## OIL PUMP / 1977 XL, XLCH, XLT, XLCR

HARLEY-DAVIDSON MOTOR CO., INC.

Oil Pump Cover, Feed Gerotors and Feed Hose Fitting

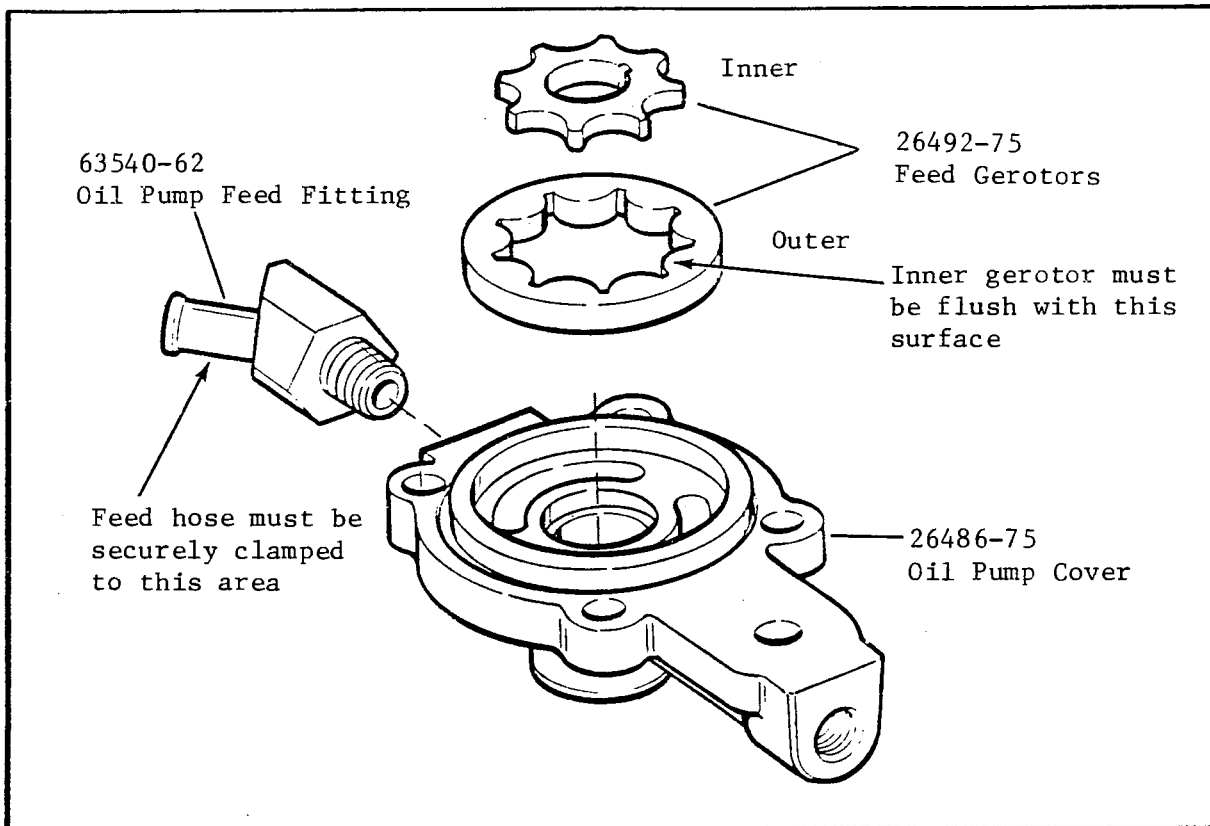
Zero gerotor (gear) side clearance must be maintained by the flat spring located between the upper and lower gerotor sets in the oil pump in order to provide adequate oil pressure. For the spring to function properly, the upper face of the lower feed gerotors must extend above the cover a slight amount to prevent any side clearance which would allow oil slippage past the gerotors and reduce oil pressure.

Another possible cause of low oil pressure is air leakage into the pump due to a loose hose clamp at the oil pump feed hose fitting, part No. 63540-62, and at the oil tank feed hose fitting. If the existing feed hose clamp, part No. 10020, cannot be evenly and securely crimped to the fittings, remove the clamp and install a worm drive hose clamp. This will prevent air leakage into the system which could cause loss of oil pressure due to an airlocked pump.

Method of Gerotor Measurement

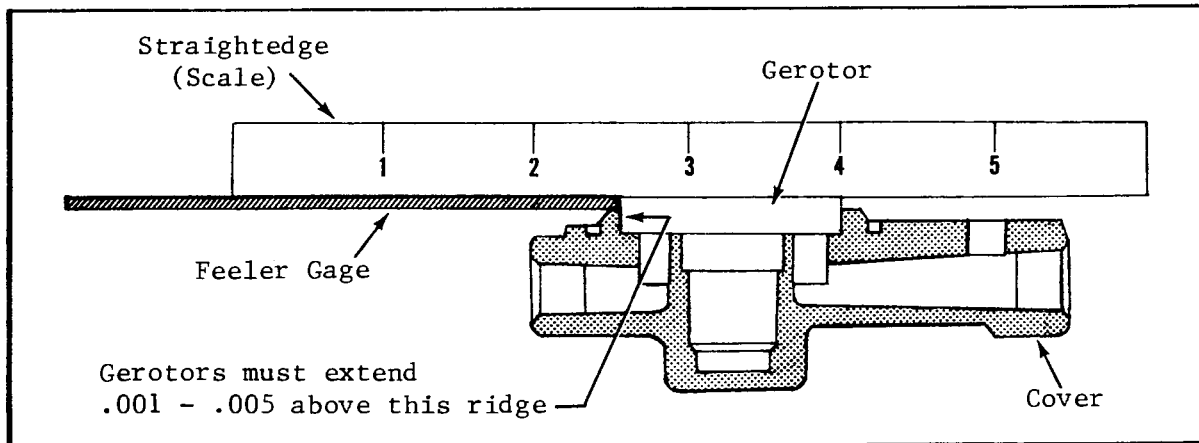
The feed (thin) gerotors, part No. 26492-75, are located within the oil pump cover, part No. 26486-75, and should extend .001" - .005" above the cover's aluminum ridge which surrounds them as measured with a feeler gage (See Illustration). The later gerotors extend up to .011" above the ridge. If the feed gerotors do not extend above the ridge within the specified range, remove them, invert cover on flat surface upon a piece of sandpaper (#280 grit to start - #400 grit to finish) and sand cover ridge evenly until the gerotors extend properly when inserted. Then, using a micrometer, check to see that both the inner and outer gerotors are the same width (thickness). If the widths measure equally but the gerotors are not equal in height when placed into the cover, the cover surface is not flat and the cover should be replaced. Be sure to check the gerotors in the new cover using a straight-edge to assure a level surface and the proper elevation above the ridge.
